Errata: CS43L42 Revision G

CS43L42 Low Voltage, Stereo DAC with Headphone Amp

Figure 1. Optional Headphone Mute Circuit for Revision G

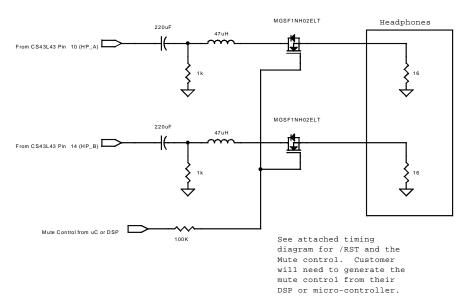
- For critical applications, the PopGuard[©] Transient Control may not be sufficient in eliminating extraneous audible artifacts on the headphone outputs during power-up. For these applications, an optional external mute can be used to maintain an absolute minimum of extraneous clicks and pops. Please see Figures 1 and 2 for the headphone mute circuit. For the line outputs, please use the optional mute circuit shown in the CDB43L42 schematic.
- The headphone outputs clip when the value of VA_HP is below VA. It is recommended that these two supplies be tied together.
- When the Analog Headphone Attenuation Control registers (02h and 03h) are set for attenuation levels greater than -10 dB, the actual attenuation deviates from the register setting by more than 1 dB.

The Motorola MOSFETs shown have been tested to work properly, however, an equivalent device may be used.
